A55 Junctions 14 and 15 Improvements

Walking, Cycling and Horse-Riding Review

A55 JUNCTIONS 15 AND 16 IMPROVEMENTS WALKING, CYCLING & HORSE-RIDING REVIEW (PRELIMINARY DESIGN)

Project name **A55 J15 and J16 Improvements**
Project no. **1620000620**
Recipient **Welsh Government**
Document type **WCHAR Review**
Version **F01**
Date **21/10/2020**
Prepared by **Nicola Evans/Ioannis Spyropoulos**
Checked by **Rob Griffiths**
Approved by **Steve Chewins**
Description **Walking, Cycling & Horse-Riding Assessment Report Review**

Project No:	Scale (@A1):	Drawn:	Date:
1620000620	1:12000	JW	DEC 18
Drawing No:		Rev:	
RAM-ZZ-ZZ-SK-J-3002		P03

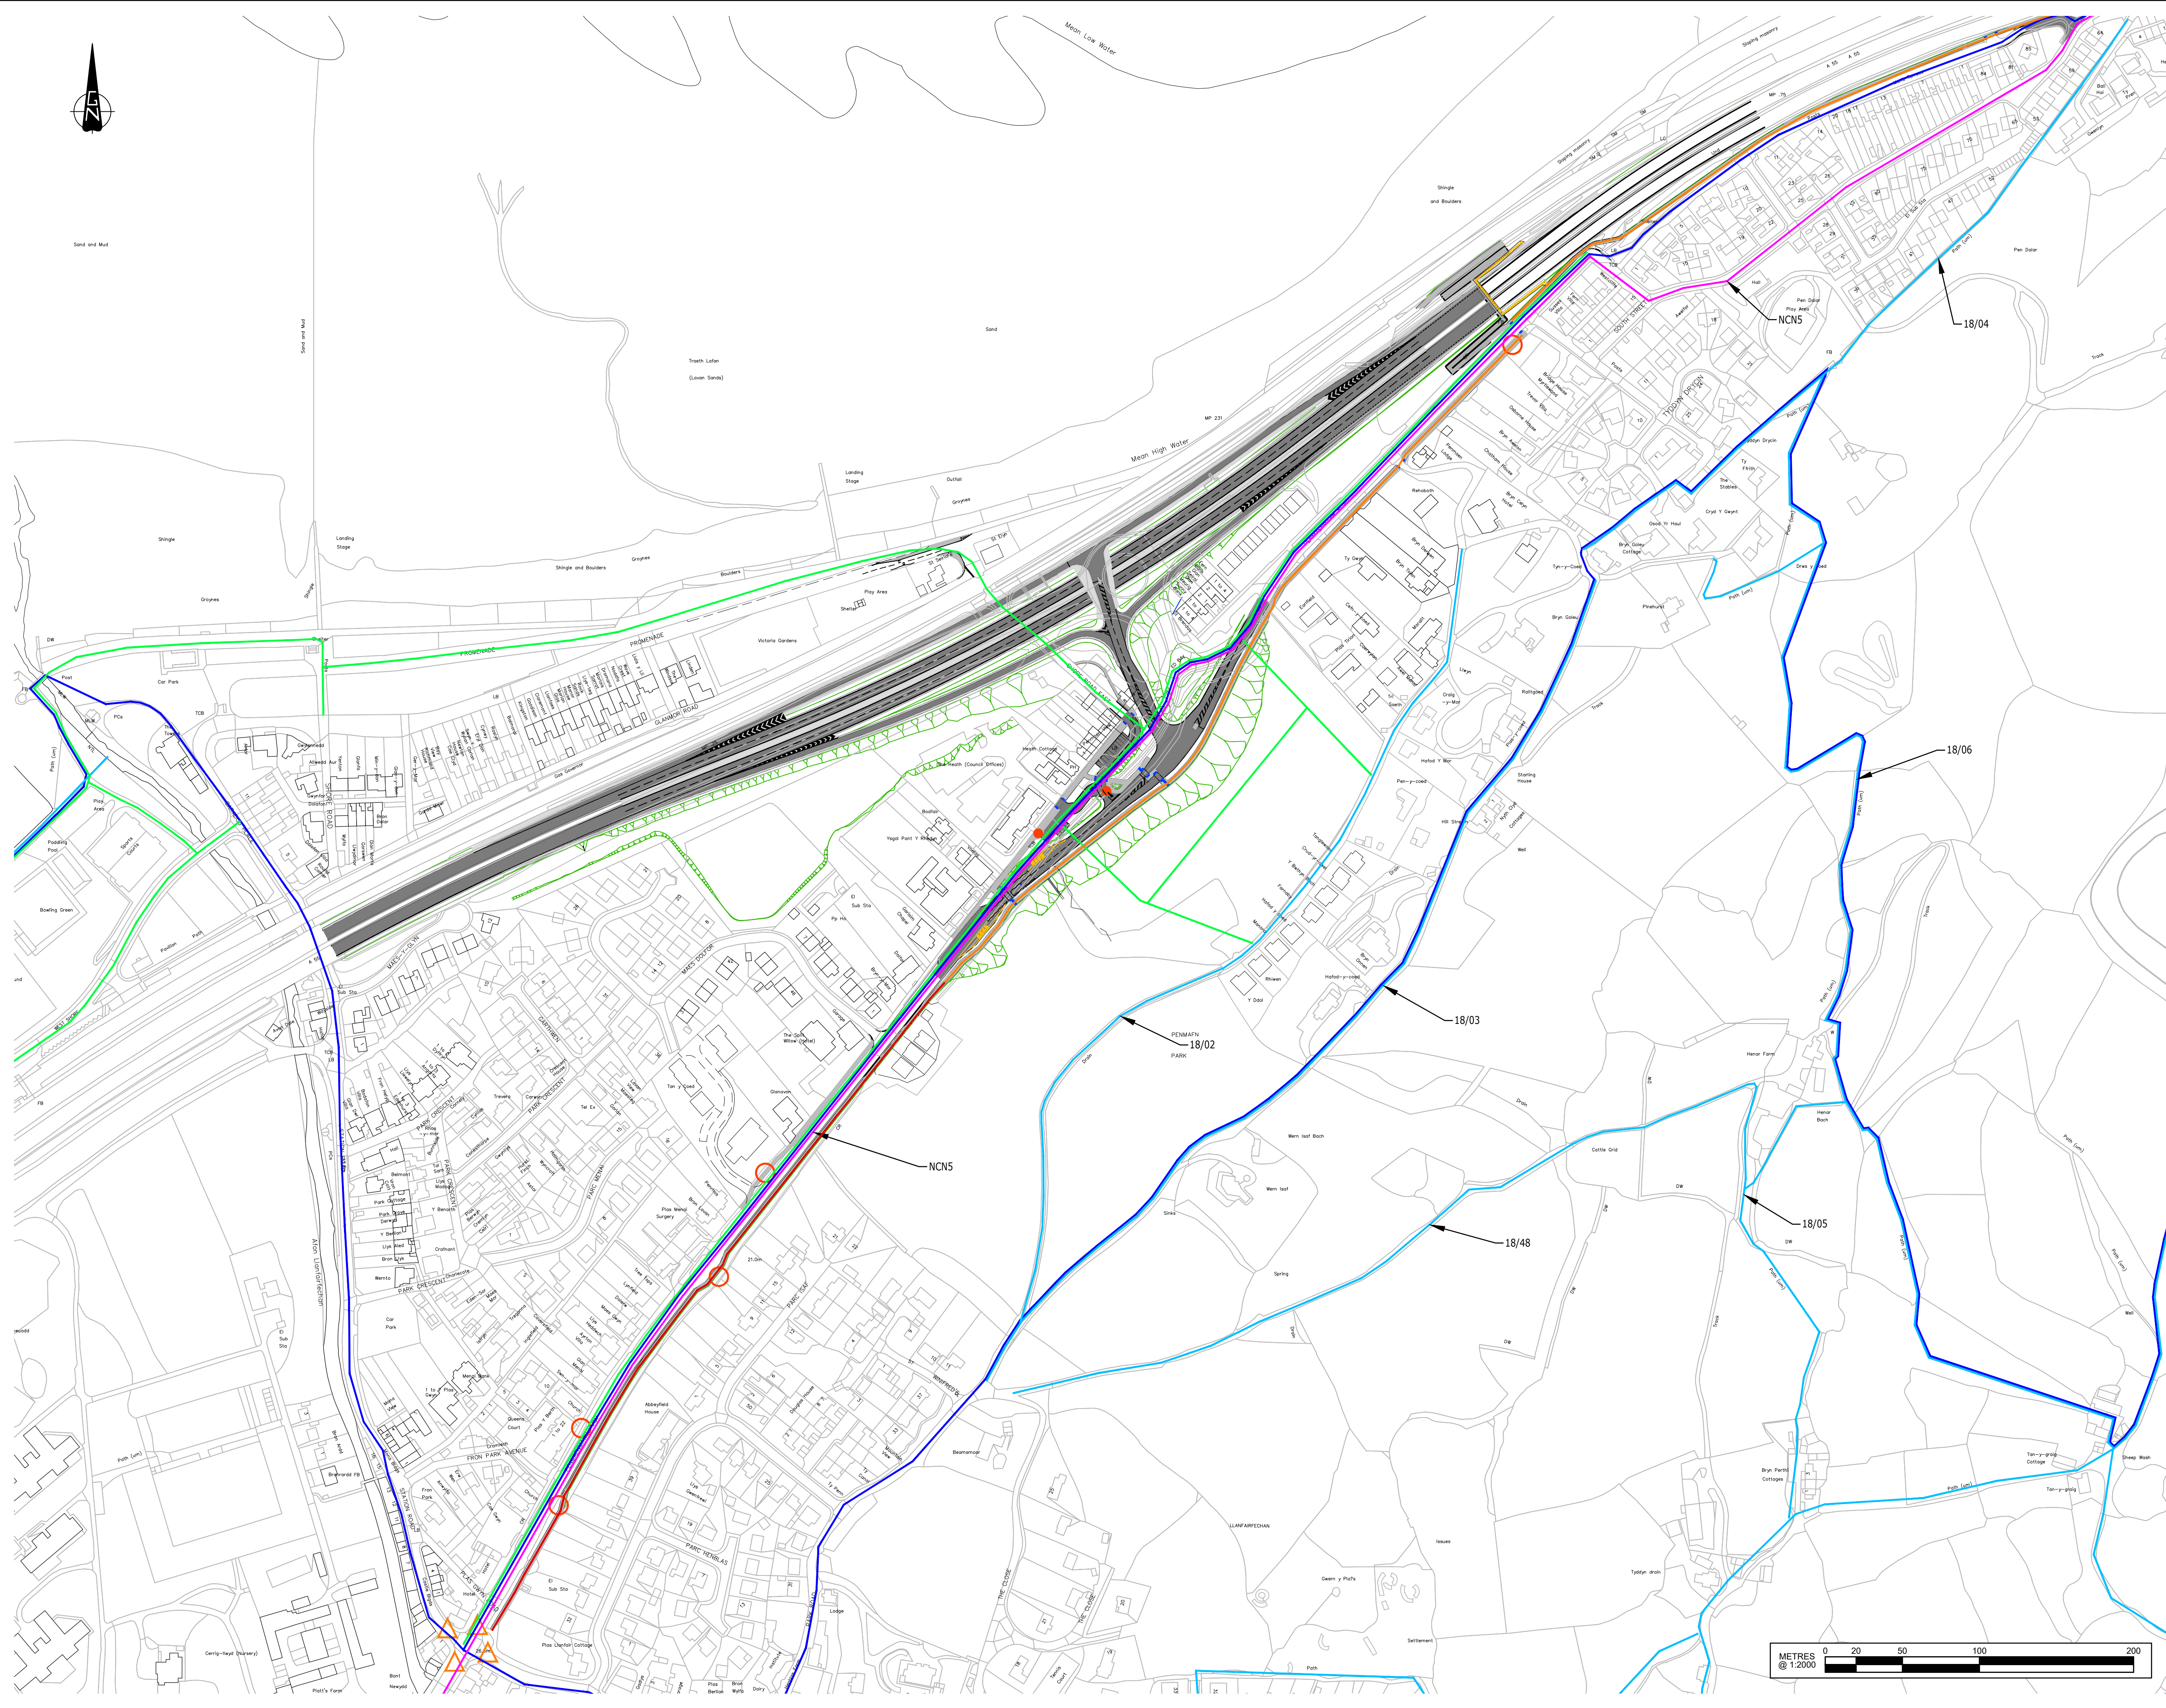
The previously issued WCHAR did not identify any specific equestrian facilities within the scheme area. On further review three bridleways within the study area have been identified, as presented in Figure RAM-ZZ-ZZ-SK-J-3002 P03 (Appendix 1).

Bridleway 18/01B is approximately 100m in length to the north of Llanfairfechan railway station, between West Shore and the Promenade. This route provides equestrians with access to the beach from the highway network.

There are also two bridleways to the south and east of Llanfairfechan (18/32 and 18/38 respectively), which provide access to the hills above.

As the scheme footprint does not currently directly impact on the Bridleways identified, therefore the assessment and review have focused on walking and cycling opportunities.

JUNCTION 15			
NMU MINI-SCHEMES			
Project No: 1620000620	Scale (8A1): 1:2000	Drawn: DB	Date: OCT 19
Drawing No: A55J15116-RAM-60-15-DR-C-0001	Rev: I02

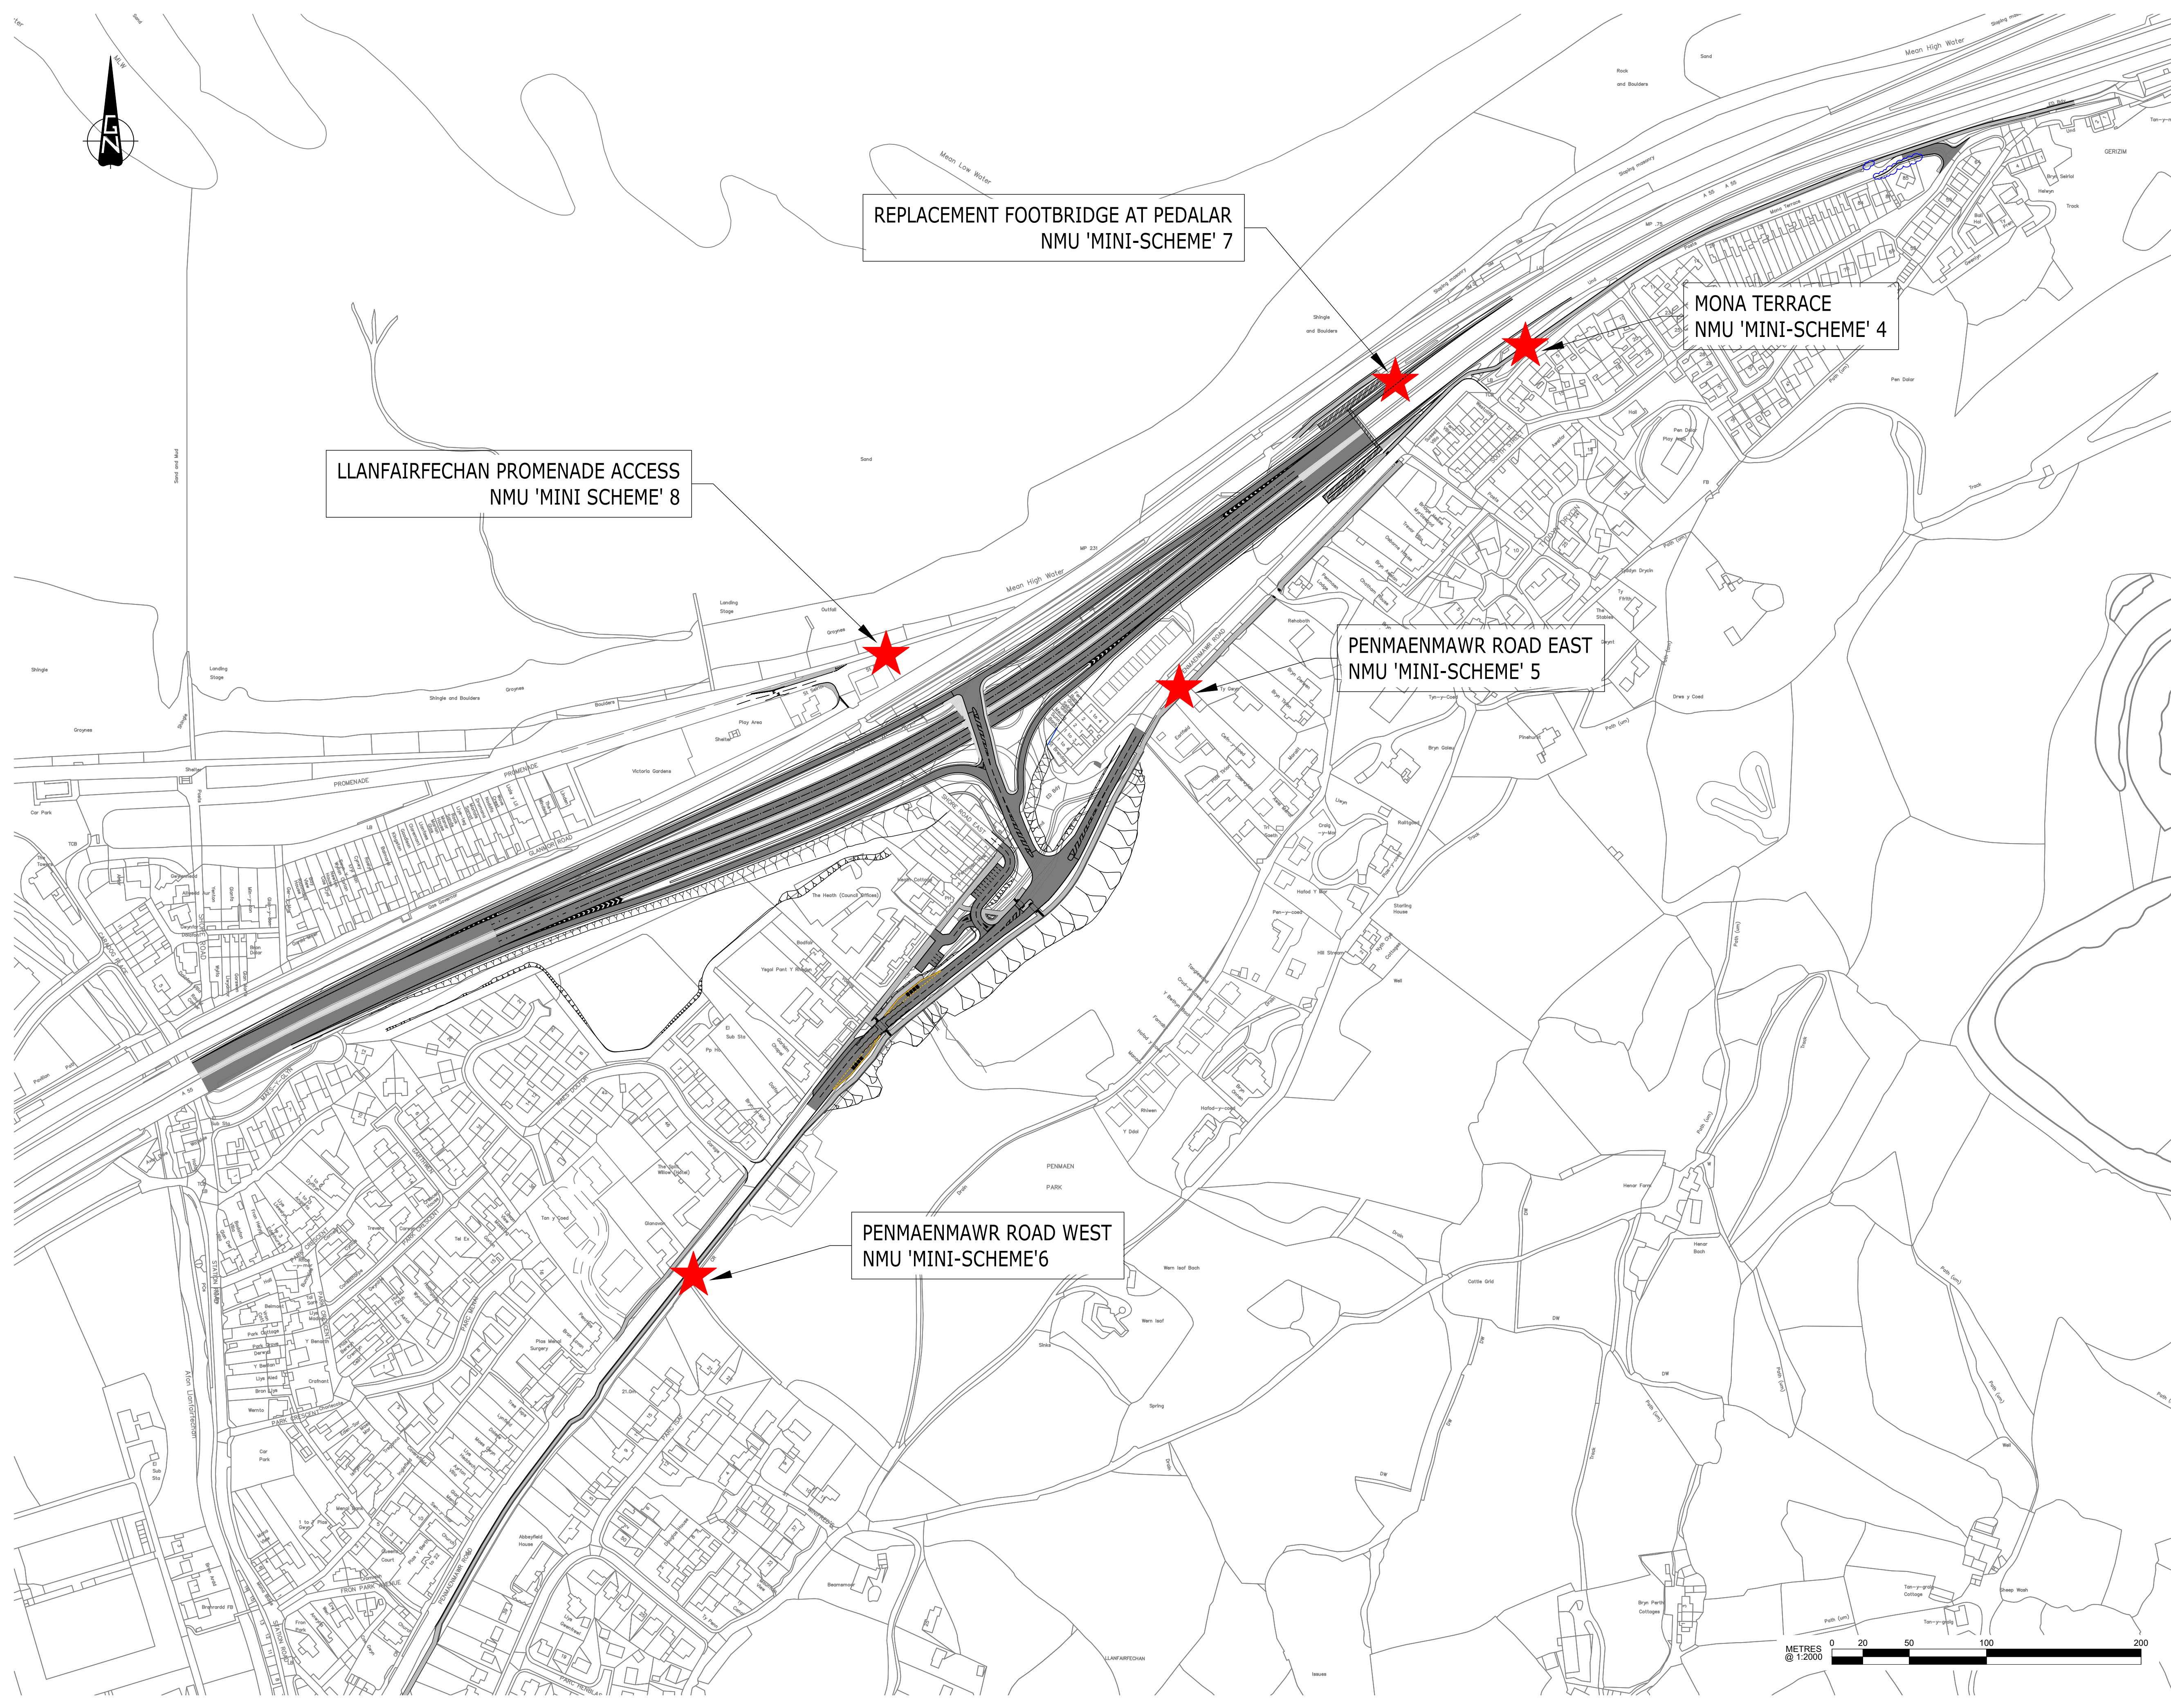
NMU Mini Scheme 5: Penmaenmawr Road - East of Junction Improvements

Consists of a 240m segregated cycle/footway way on the verge adjacent to the existing highway. The off-road cycle/footway would provide a link from Penmaenmawr to the replacement footbridge. In addition, the link would also provide on off road cycle/footway from Pendalar to Ysgol Pant Y Rhedyn.

NUM Mini Scheme 6: Penmaenmawr Road - West of Junction Improvements

The Scheme consists of a 550m segregated cycleway/footway to south side of Penmaenmawr Road, providing a direct route into the village centre and associated local facilities. The cycleway also provides a segregated route between Llanfairfechan village and Ysgol Pant Y Rhedyn. The existing route on the north side is maintained as footway only.

NMU Mini Scheme 7: Replacement footbridge at Pendalar

Consists of a replacement footbridge with Disability Discrimination Act (DDA) compliant ramps and enhanced access, to replace a footbridge that would no longer fit due to the increased span. This would provide improved access to the coast.

NMU Mini Scheme 8: Llanfairfechan Promenade Access

Improvements would include the reconfiguration of the existing walls to improve cycle access, whilst maintaining level of protection for tidal flooding. The works would tie into the shared open space improvements which extend along Shore Road East.
